DATE: October 2, 2023

TO: Mayor Tom Reed, City of Chattahoochee Hills
ATTN TO: Mike Morton, Community Development Director, City of Chattahoochee Hills
FROM: Mike Alexander, COO, Atlanta Regional Commission
RE: Development of Regional Impact (DRI) Review

Name of Proposal: Creative Land Co LLC DRI 4027

Description: A DRI review of a proposal to construct a mixed-use development with 607 residential units (200 multi-family, 167 townhomes, 240 single-family homes), 100 hotel rooms, and 14,000 SF of retail space on an approximately 265-acre site between Creel Road and Cochran Mill Road in the City of Chattahoochee Hills in Fulton County.

DRI #4027

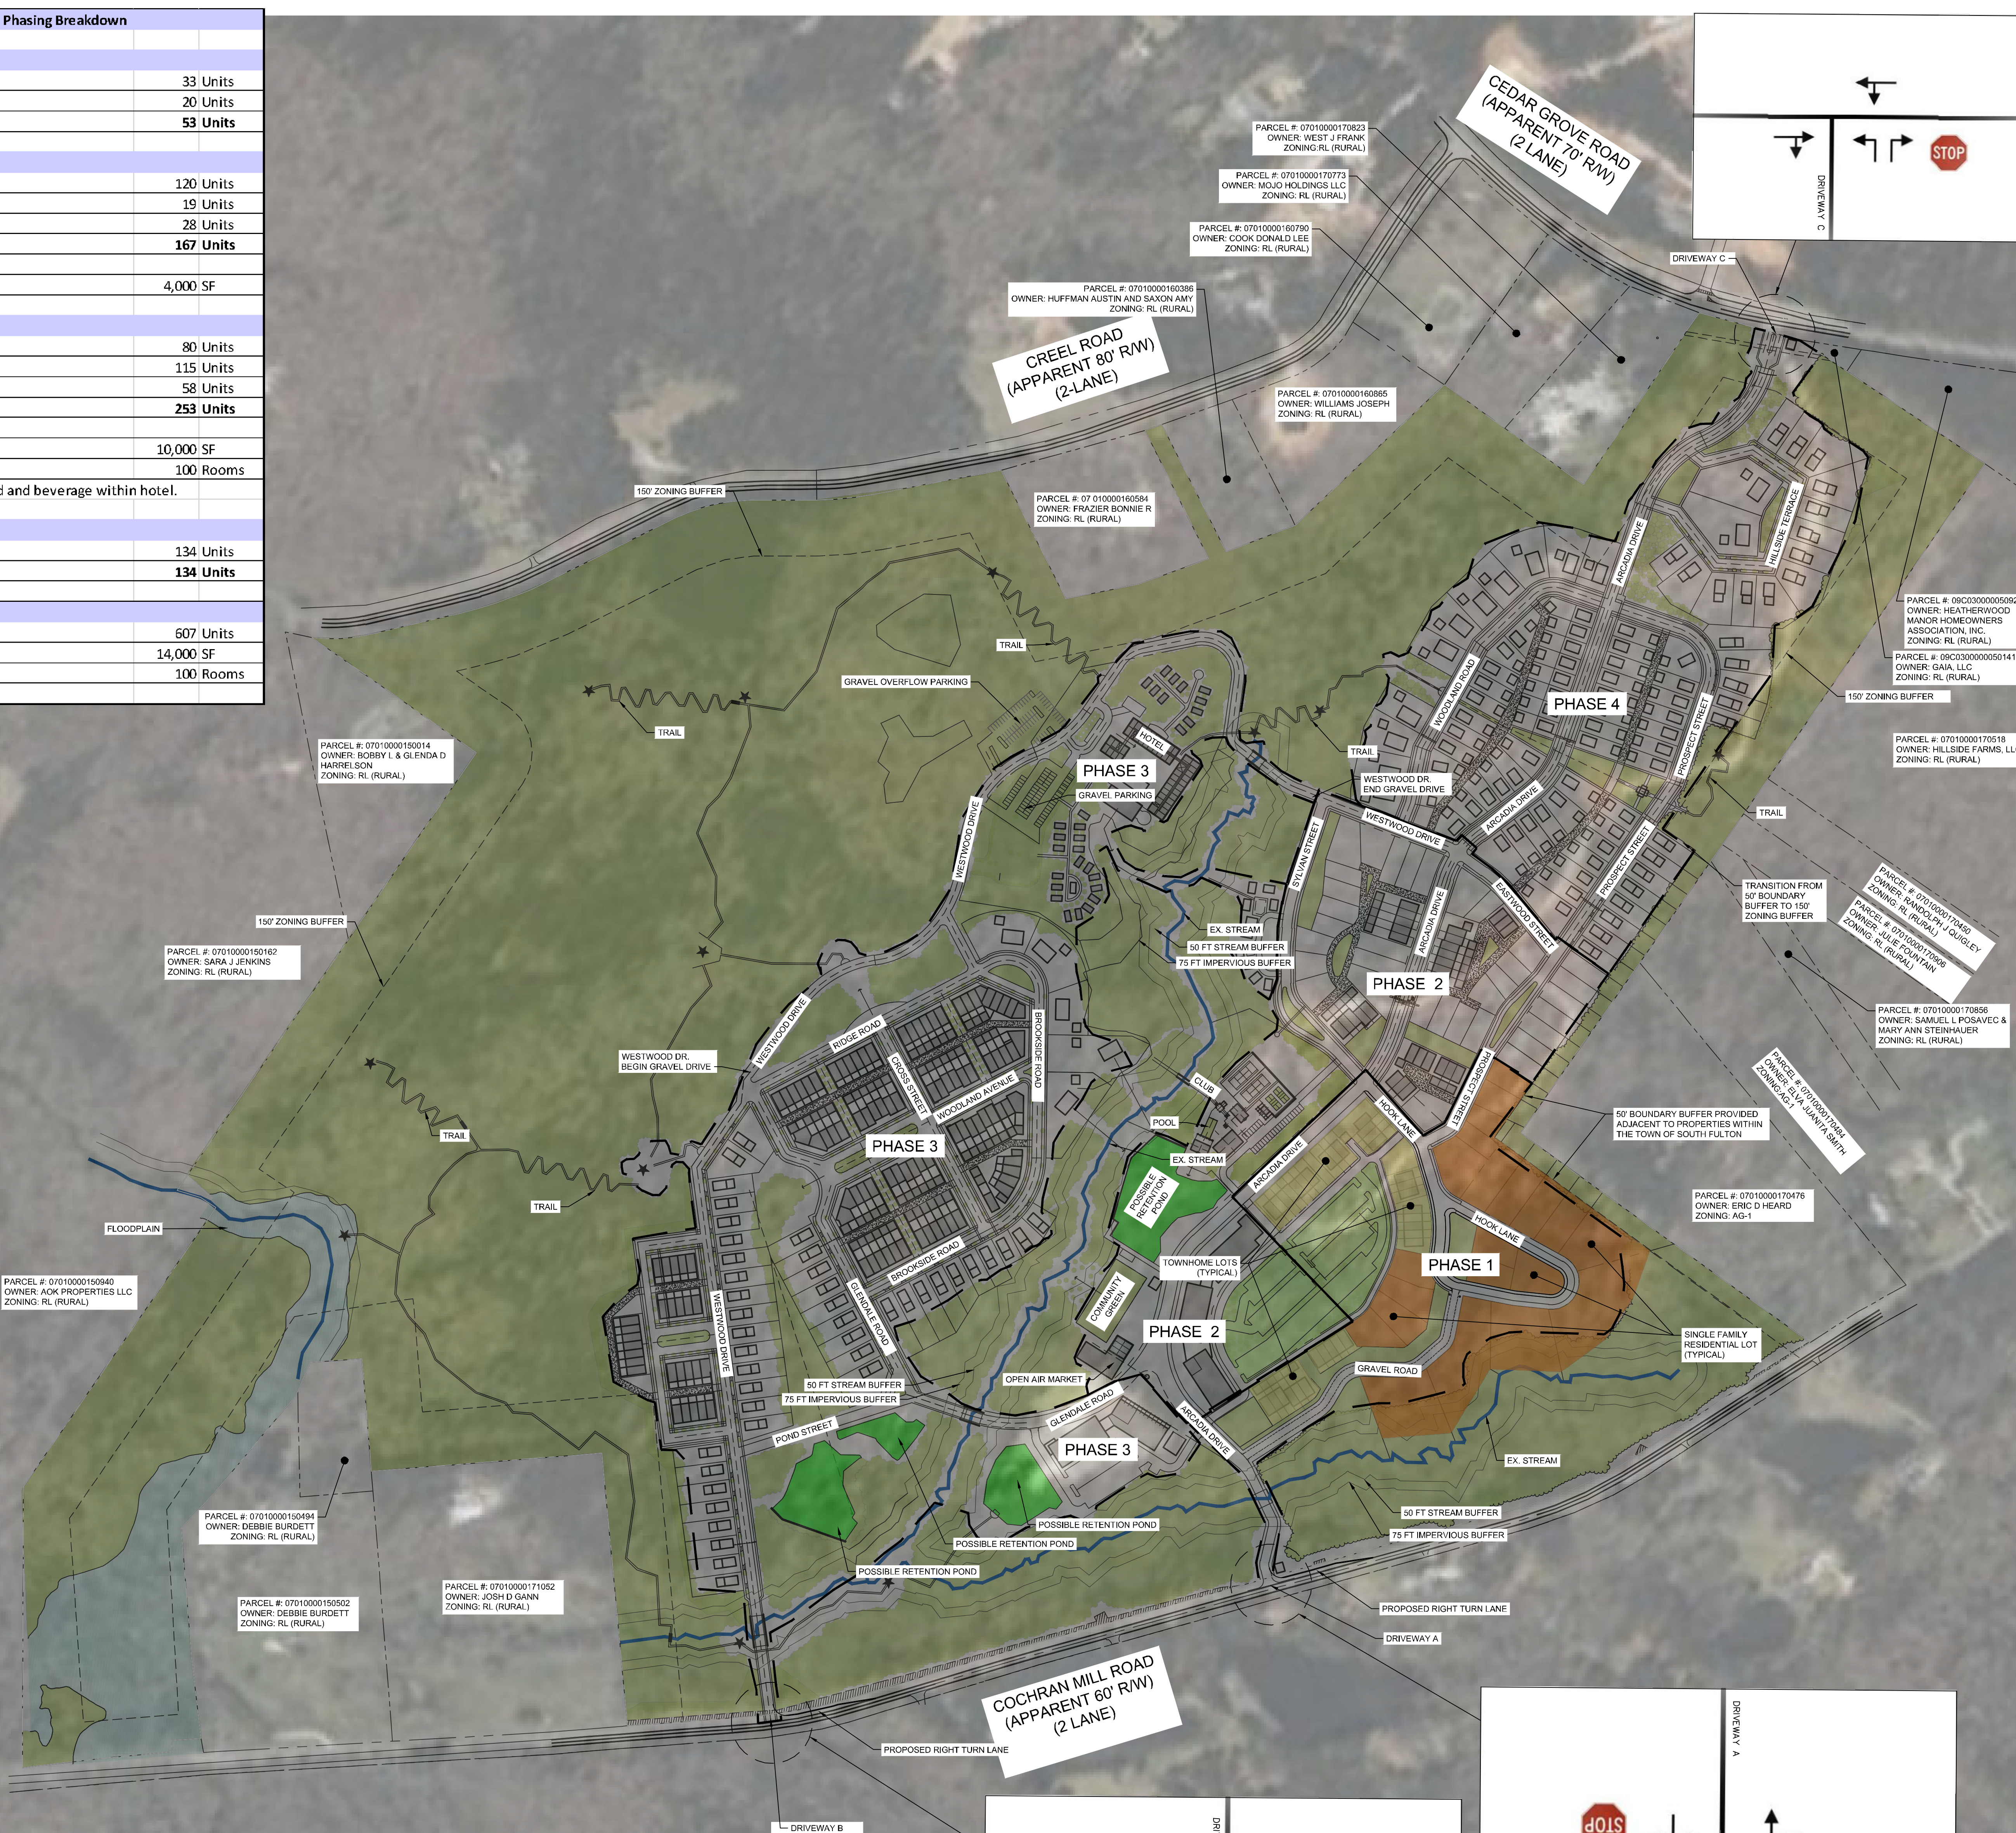
The State 25-foot Erosion and Sedimentation Buffer should be shown on all streams and the City of Chattahoochee Hills stream buffers should be shown on both sides of Pea Creek.

Several single-family lots in Phase 1 of the project extend into stream buffer and setback areas. Actual development on these lots should avoid extending into stream buffer areas in order to avoid the need for variances.

ARC's Natural Resource Group comments are attached. Both the project site plan and the USGS coverage for the project area show Pea Creek at the southwestern end of the property, along with an unnamed tributary to Pea Creek running from Northeast to southwest, roughly paralleling Cochran Mill Road, as well as a branch off that tributary in the center of the property. The site plan shows and identifies the 50-foot undisturbed buffer and 75-foot impervious surface setback required under the City of Chattahoochee Hills Stream Buffer ordinance on the two unnamed tributary streams. The buffers are shown on only one side of Pea Creek, where a trail and overlook are shown. No buffers are shown on the southwest side of the stream, where no development is indicated. The State 25-foot Erosion and Sedimentation Buffer is not shown on any stream. The only intrusions shown on the submitted site plan are transportation crossings, which are allowed under the City ordinance. However, several single-family lots in Phase 1 of project extend into the buffer and setback. Development on these lots that extends into the buffer and setback may require variances. The State 25-foot Erosion and Sedimentation Buffer should be shown on all streams and the City buffers should be shown on both sides of Pea Creek unless the City ordinance allows otherwise. Any unmapped streams on the property may also be subject to the requirements of the City Stream Buffer Ordinances and any other waters of the State on the property will be subject to the 25-foot state Erosion and Sedimentation Act buffers.
